Re: Section 16 Planning Application for Proposed Temporary Eating Place and Shop and Services for a Period of 5 Years at Lot 515 and 516 RP in D.D. 130 and Adjoining Government Land in San Hing Tsuen, Lam Tei, Tuen Mun, New Territories
(Planning Application No. A/TM-LTYY/493)

Responses	to	Comments	Table

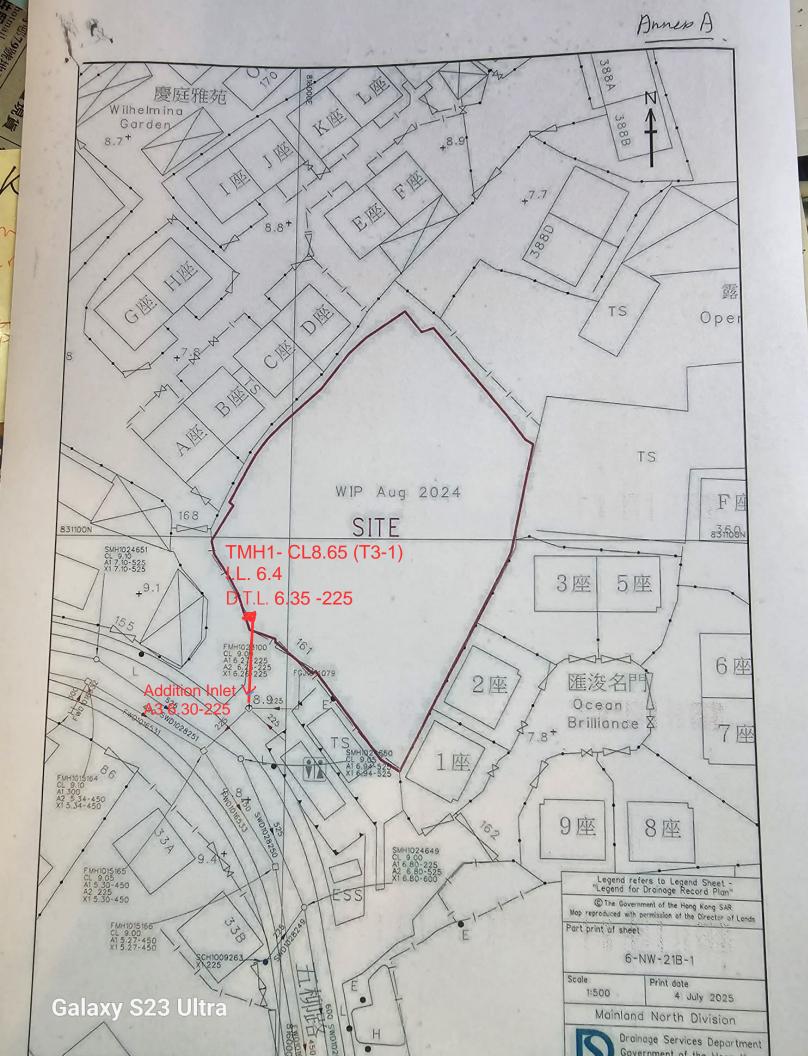
Department	Date	Comments	Responses to Departmental Comments
Drainage Services Department	4.8.2025	1. Re: Sketch on page 10 of Appendix I, (i) Please indicate the type of terminal manhole TMH1, which should be Type T1_1, T2_1, T3_1, T4_1 or T10_1 as appropriate and in accordance with current DSD standard drawings. Furthermore, the D.T.L. should be indicated on the drawing complying with the current Government standard and a 150mm difference between I.L. and D.T.L. should be maintained.	Noted, the terminal manhole TMH1 will be using Type T3_1 and I.L. +6.4 and D.T.L. +6.35 (Please refer to the attached).
		(ii) Please advise the material of the proposed sewer connection pipe. Polyethylene pipes should general be used for sewer connections. Proposals for using pipes of alternative materials should be submitted for agreement. Reference should also be made to Sewerage Manual published by DSD.	Proposed sewer connection pipe will be using Polyethylene Pipes as per DSD requirements.

(iii) Please indicate the downstream invert level of the proposed sewer connection pipe at the existing FMH1023100.	Noted. The downstream invert level of the proposed sewer connection pipe at the existing FMH102310 will be at +6.30 (Please refer to the attached).
